Crystal River Unit 3
Docket No. 50-302

March 12, 1996
3F0396-08

Subject: Inservice Inspection Program (ISI) Relief Request 95-030, Supplement 2

FLORIDA POWER CORPORATION
INSERVICE INSPECTION
RELIEF REQUEST # 95-030
SUPPLEMENT 2
CRYSTAL RIVER UNIT 3

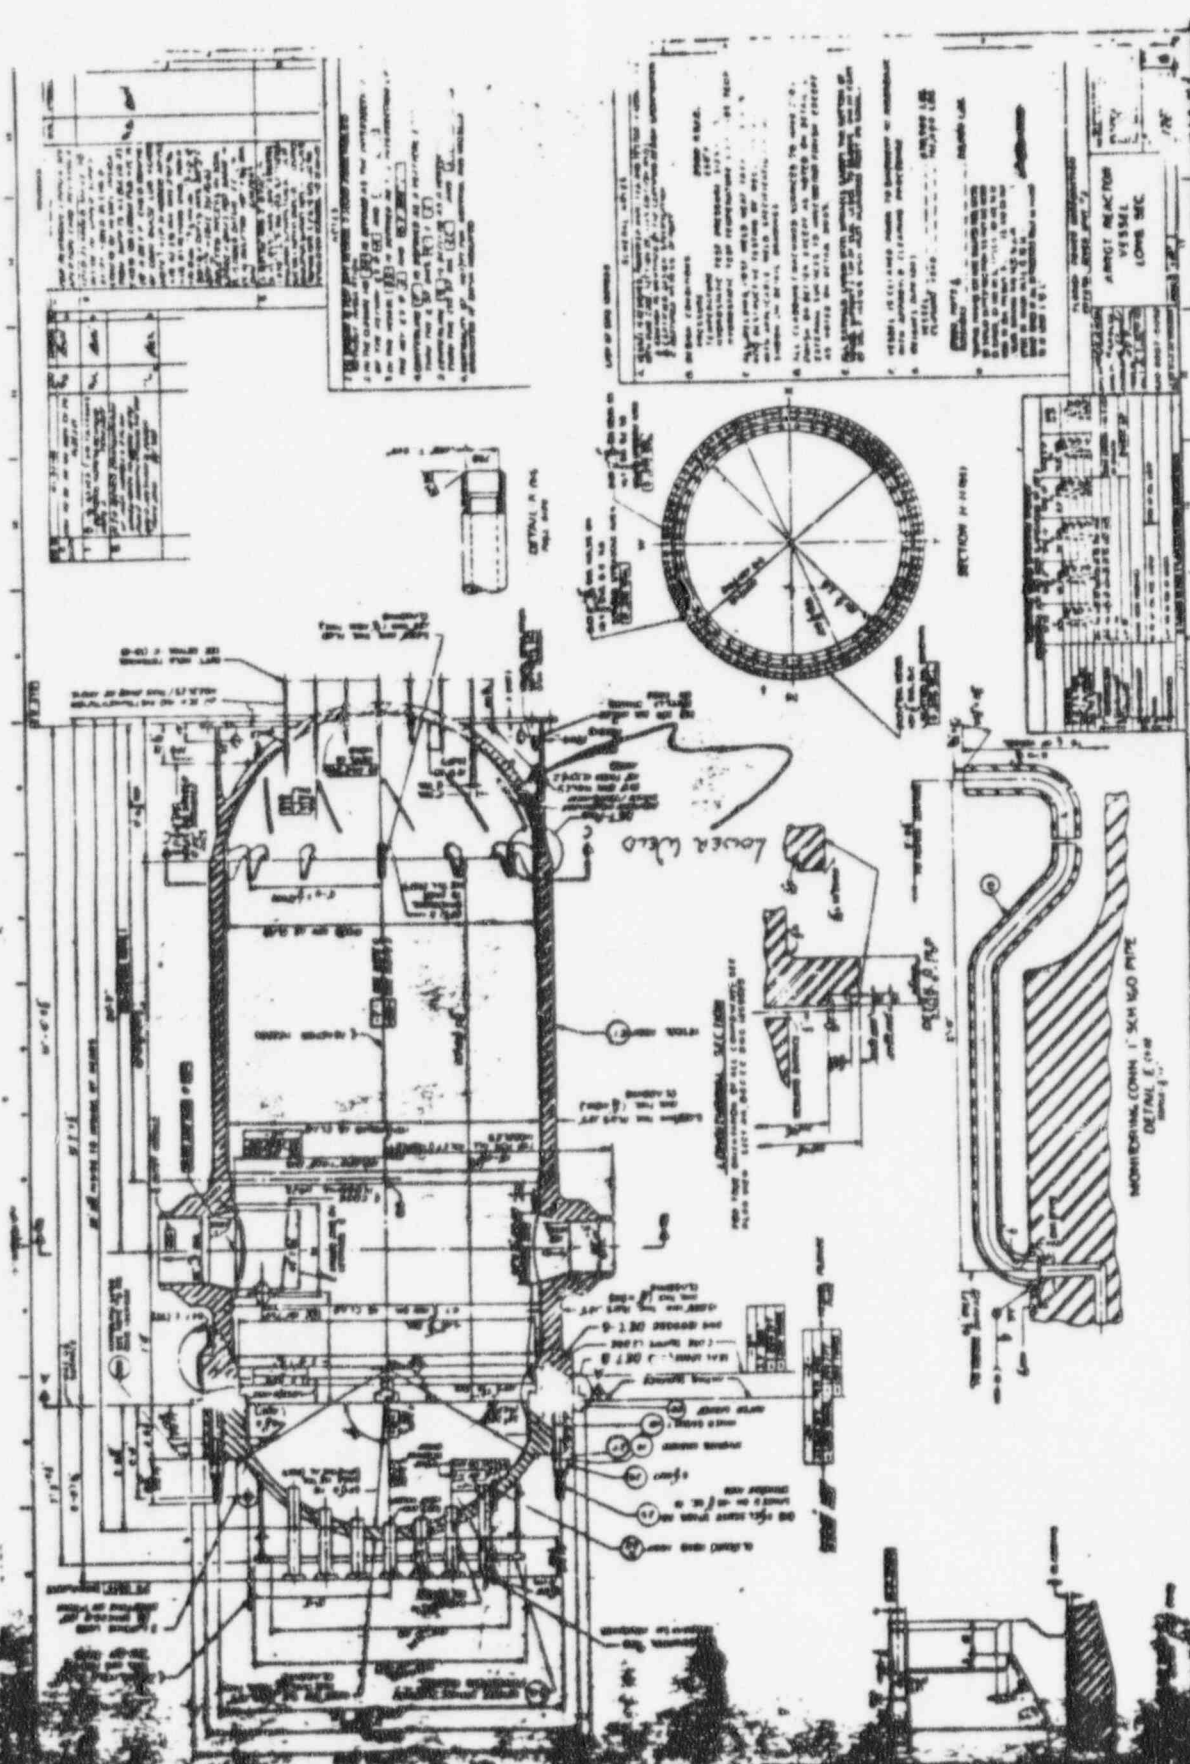
The licensee cites limited access for examination and the potential for damage of incore instrumentation by the examination tool. Provide a detailed access study and determine the actual probability for potential damage due to the inspection tooling, (i.e. considering clearance requirements, tool operations, etc.). In addition, provide instances where damage, if any associated with the subject weld has occurred, the result of the use of the inspection tool at your plant or at any other plant with similar reactor pressure vessel designs.

The Framatome robotic manipulator (URSULA) employs a two by two matrix of contact type ultrasonic transducers in the scanning head. In order to scan a weld, the transducer shoe must be in contact with the vessel surface. As can be seen from the attached drawings (B&W Dwg #'s 126951 and 135543) the area surrounding the lower head to transition piece weld is extremely congested with other reactor vessel components, such as the guide lugs, the incore instrumentation guide tubes, and the remnants of the lower flow stabilizers. The reactor vessel component of immediate concern, should an impact occur with the URSULA scanning head, are the incore instrument guide tubes. These slender tubes protrude from the inner surface of the lower head approximately 12 inches and are less than 1 inch in diameter. Alignment of these tubes is critical as they are inserted into a mating tube on the lower section of the core barrel when it is replaced. Any misalignment of these tubes due to an impact with the scanning head would cause significant damage not only to the incore guide tube, but also to the mating tube on the core support assembly and any adjacent tubes if significant deflection were to occur while installing the core barrel. Repair to the damaged incore instrumentation guide tube and any other affected components would cause significant critical path delays to the outage schedule.

Another issue to be contended with is the potential for damage to the URSULA manipulator arm due to an impact with one or more of the obstructions in the vicinity of the weld. This is significant from the stand point of accurate transducer positioning. If damage were to occur to the arm such that it is unable to calculate its position relative to the base unit, accurate positioning of the UT data being collected would be lost. To recover from this situation would entail repair of the manipulator arm and a rescan of the weld; both evolutions adding to the critical path time of the schedule and dose exposure for the job.

The first time deployment of the URSULA manipulator to a B&W reactor vessel was at ENTERGY's ANO-1. While developing the scan plan for the vessel inspection, it was determined that access to the lower head to transition piece weld would be limited to less than 7 %. The scan plan was developed using 3D CAD software (ROBOCAD) which incorporates the actual vessel dimensions and all the interferences. This allowed the programmers to determine how much of the weld would actually be accessible for scanning.

Figure 4. P-T Curve for Bottom Head Region for Flaw Sizes of 1/4T, 3/8T and 1/2T

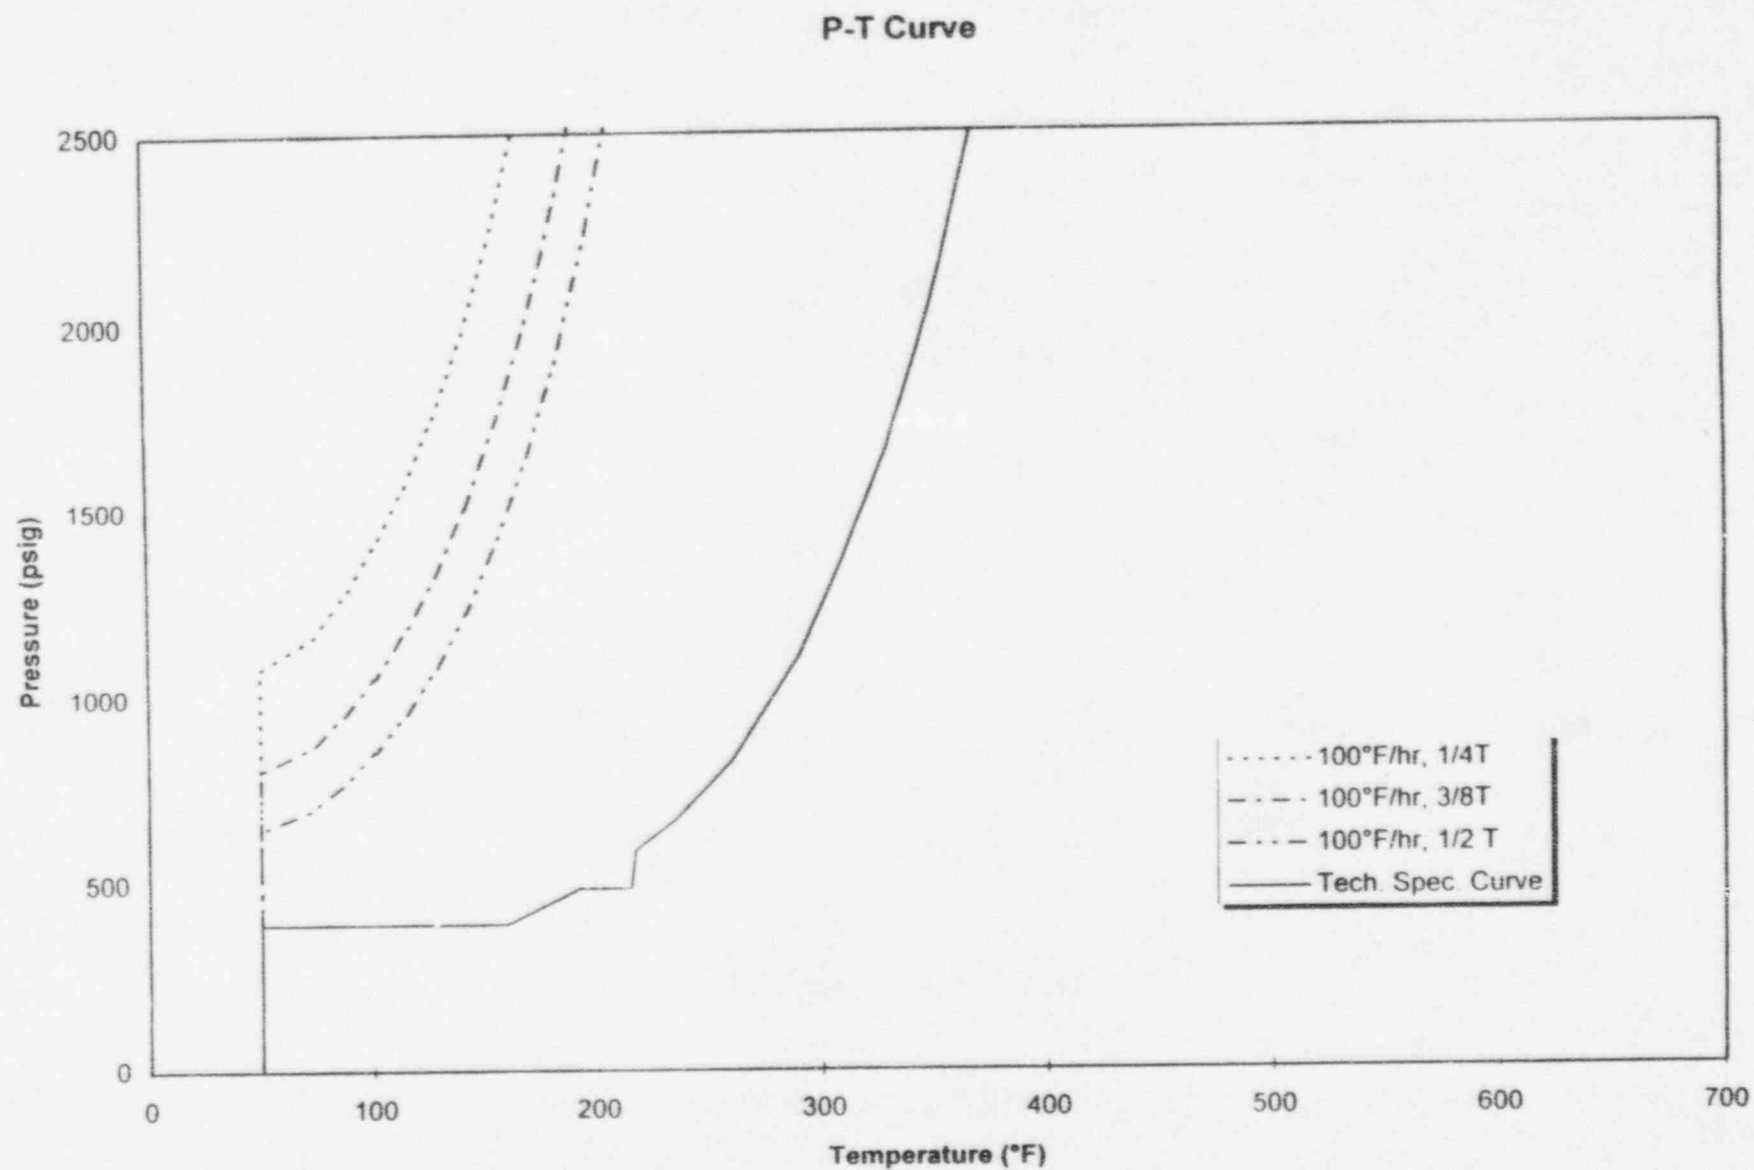
The licensee essentially proposes the elimination of the subject volumetric Code examination of the accessible portions of the weld. This implies that other RPV welds are more susceptible to failure than the subject weld. Based on a qualitative comparison of the fracture toughness of the beltline weld to the lower head weld, what is the estimated critical flaw size for the lower head weld (Appendix G ASME Code flaw size.)?

Spec. curve up to 100°F/hr were evaluated with respect to both outside surface and inside surface flaws. The limiting 100°F/hr results are shown in Figure 4 for all three flaw sizes, and are compared against the currently established Tech. Spec. P-T curve based on the limiting beltline region, for the hydrotest condition.

The results shown in Figure 4 demonstrate that the current P-T curve for the limiting beltline region significantly bounds that of the lower head region. For flaw sizes as large as 1/2T, significant margin remains. The primary reason for the significant difference between the bottom head and beltline regions is a result of decreased beltline toughness caused by irradiation. This effect is apparent when the adjusted reference temperature (ART) of 208°F (using the fluence specified on the Tech. Spec. P-T curve) for the limiting beltline material (upper shell plate) is compared to the 16.9°F value described above for the limiting bottom head material (head transition piece). Thus, the fracture toughness capability of the bottom head region is significantly bounded by the existing Tech. Spec. P-T curve for the beltline region.
